**CORRIGENDUM**

**Limited Tender Enquiry No. Q/NIB/18-19/38 dt. 27.08.2018**

**Description: For supply and installation of furniture items for furnishing of  
DS-IVDL/IT Cell & Bioinformatics Centre.**

PROPOSED BIOINFORMATICS CENTRE

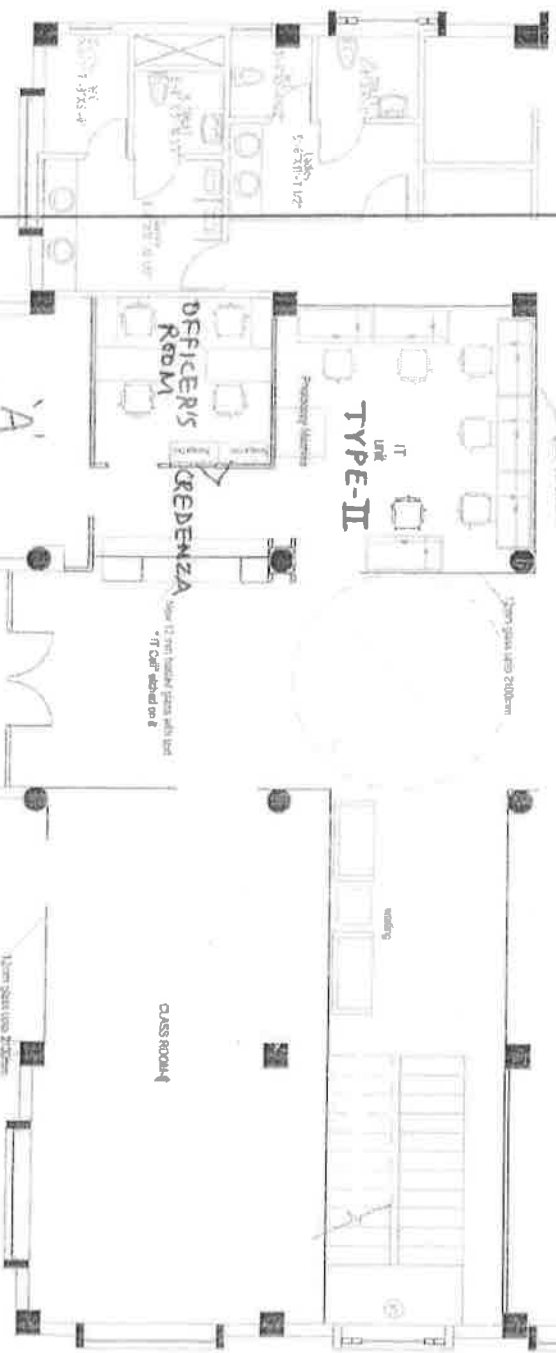
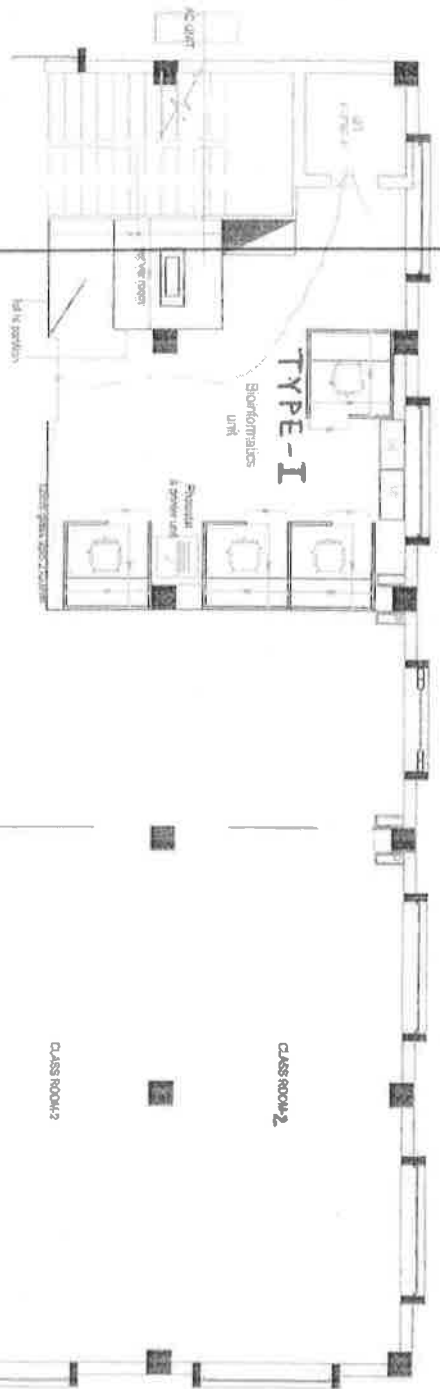
S.No.	Queries	Reply
1.	<p><b>SECTION- VI: SR. NO. 01 &amp; 02 WORKSTATION TYPE-I AND II:-</b></p> <p>A. Please send us layout plan to understand what type of workstation you desire.</p> <p>B. 4 Nos. of seating as per layout or 1 No. of 4 Seating per layout, and same for type II quantity. Please confirm the quantity type-I &amp; type-II.</p> <p>C. Please ensure partition will be in the range of 50-60mm thickness.</p> <p>D. Drawer cabinet: please cleared you need 3 drawer pedestal ( 2+1) of or cabinet. Also show size for the same.</p>	<p>A. Furniture Layout plan showing placement of work stations (Type-I &amp; Type II) table, chairs, storage units is as per attached image.</p> <p>B. Type I &amp; Type II work stations are to be placed in row manner along walls. Type I work station are cubical type i.e. closed from four sides, as per attached image.</p> <p>C. Minimum thickness has been specified 38mm., however 50mm. to 60 mm. thickness of modular work station can also be accepted.</p> <p>D. Three (3) Drawer pedestal i.e. Box-Box-File (2+1) is required. The size of pedestal will be 400 mm (L) x 450mm (D) x 685 mm (Ht.)</p>

740mmh, it will be 1350/1500 x 600/750 x 750mmh. Please clear. Also need drawing for the same.	depth two drawers on top. Bottom portion shall have one shelf at middle with sliding doors.
3.	<b>SECTION- VI: SR. NO. 04 OFFICE CHAIR ( SKY BLUE):-</b> Please provide images of chairs.	Please see the attached image.
4.	<b>SECTION- VI: SR. NO. 05 LATERAAL FILLING CABINETS:-</b> Need images layout plan	Please see the attached image.
5.	<b>SECTION- VI: SR. NO. 06 CREDENZA:-</b> need images/ layout plan	Placement shown in the layout plan. (Officer's Room).
